**Glastonbury Riverfront Park
Phase Two Improvements
Project No. GL-2013-22
Glastonbury, CT.**

**ADDENDUM NO. 005
May 23, 2013**

EXHIBIT "D"
CREW LAUNCH SKETCH W-102

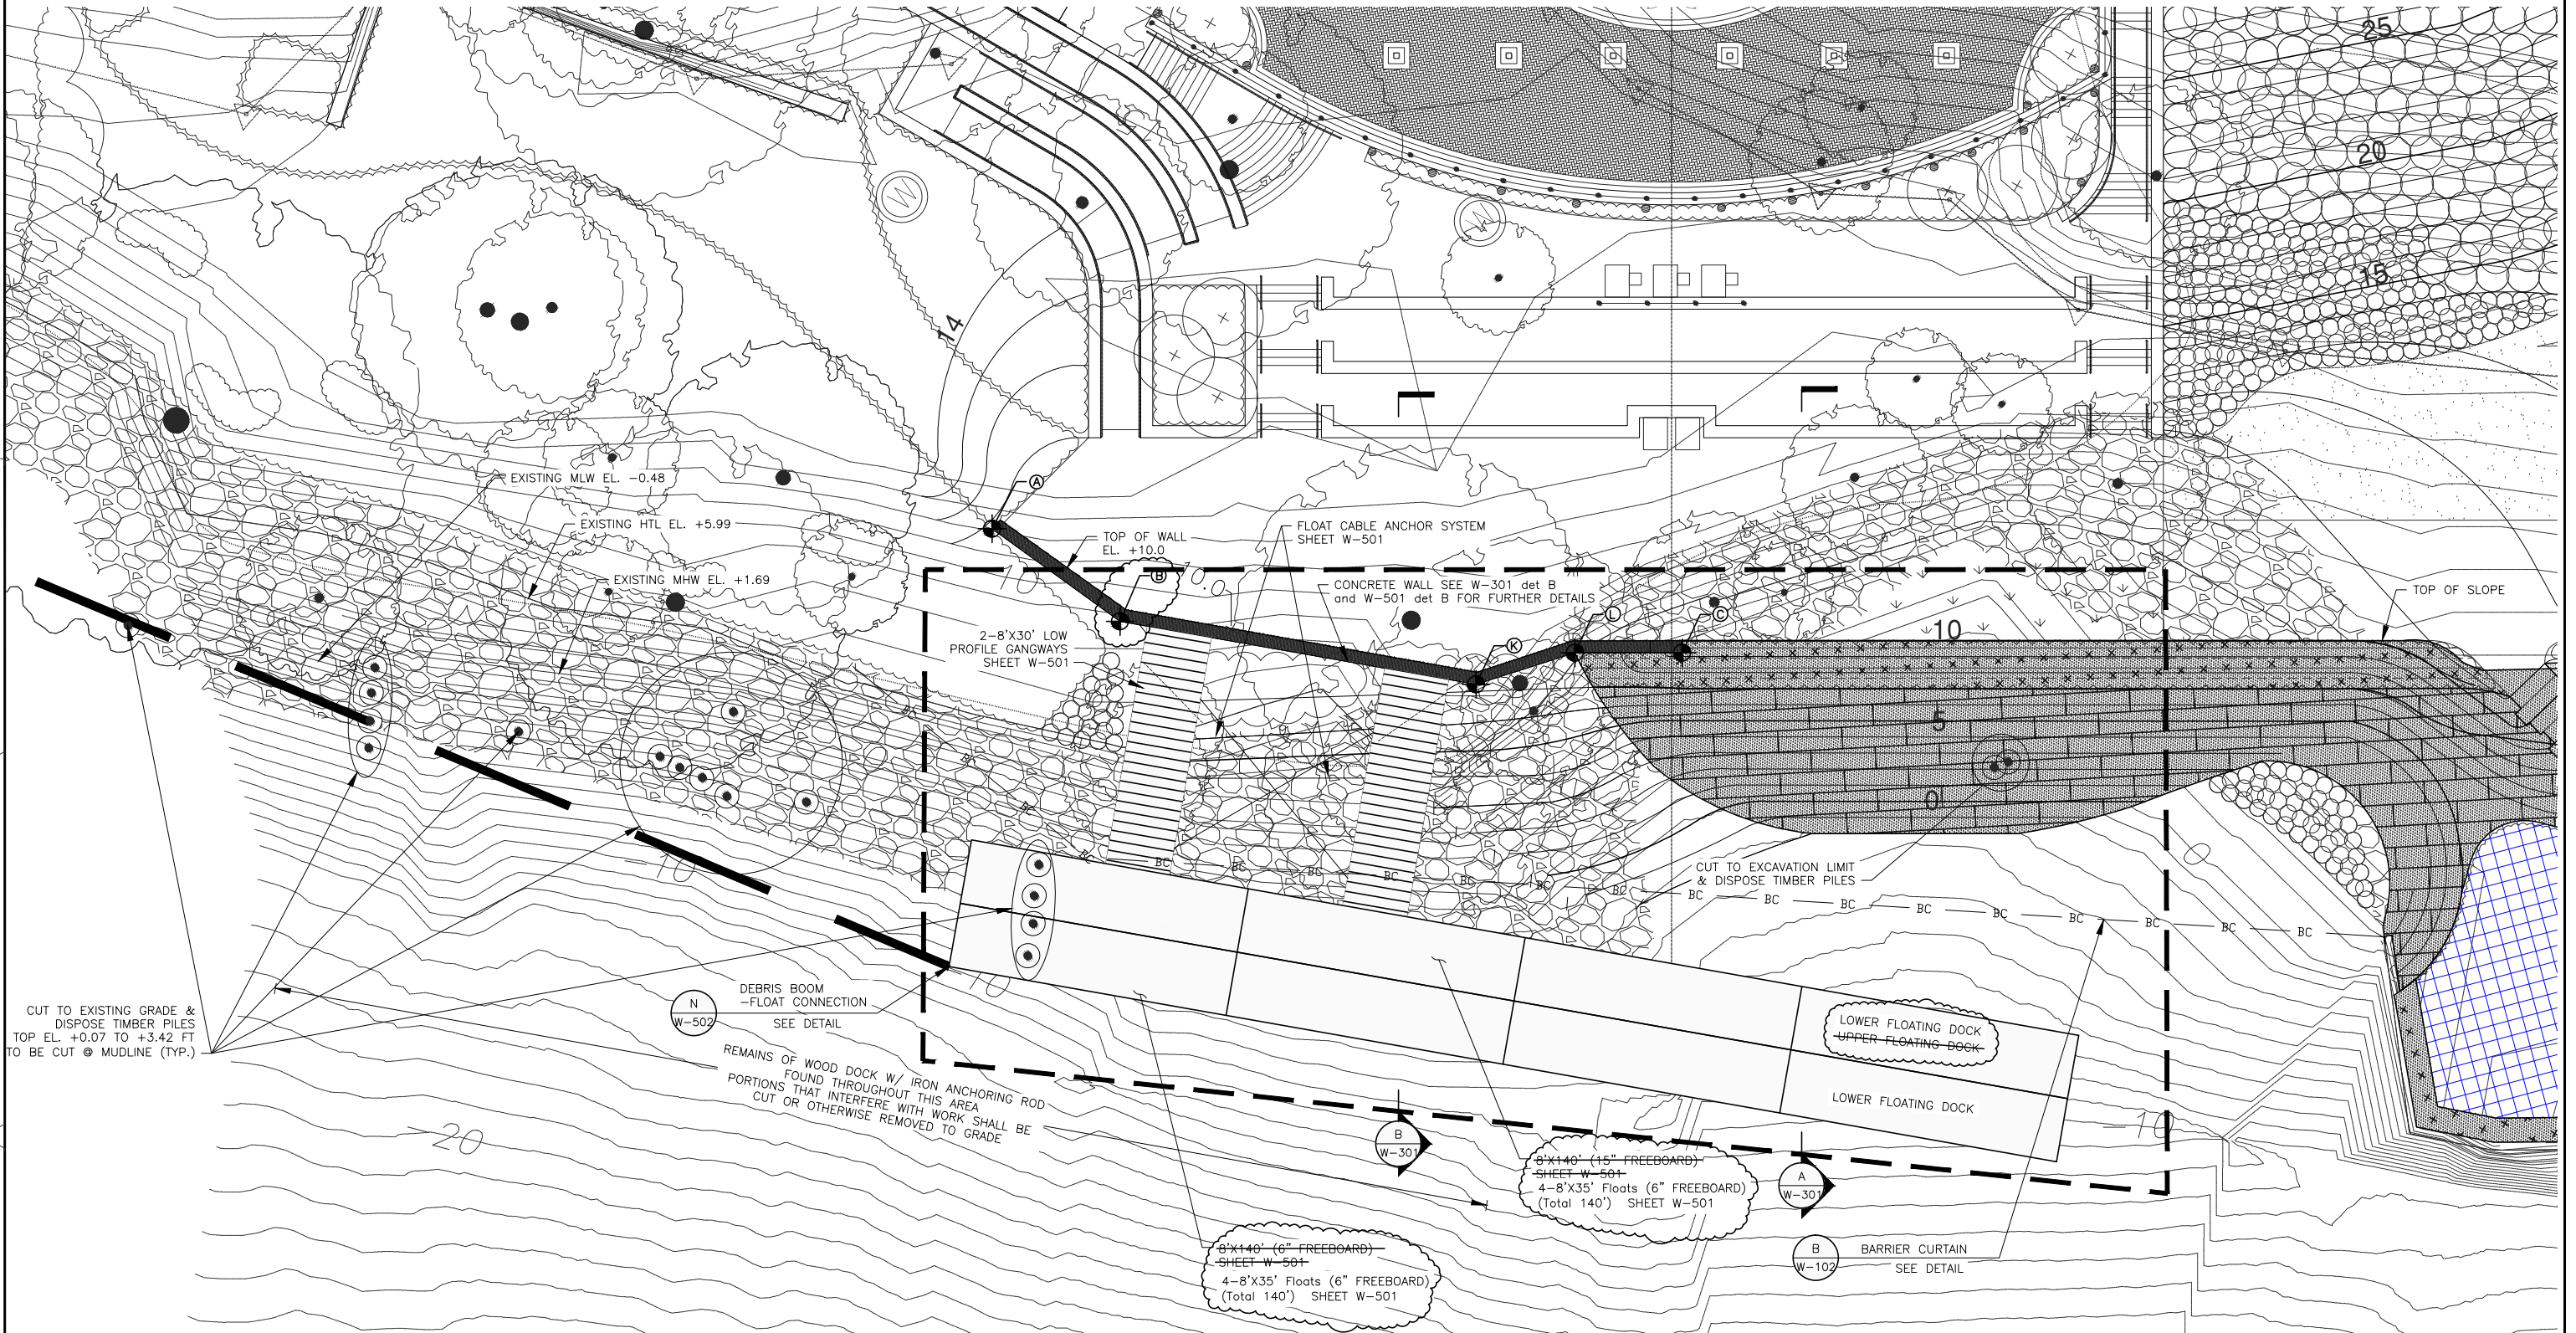
Drawing A/W-102 Following revisions have been made to the drawing as follows:

- Coordinate for Point B has been moved in shore.
 - Gangways shall still be installed perpendicular to the concrete wall.
 - Crew Floats will be rotated with south end further out shore.
 - The 8’ X 140’ Upper Floating Dock with 15” freeboard has been replaced with an 8’ x 140’ Lower Floating Dock with 6” freeboard.
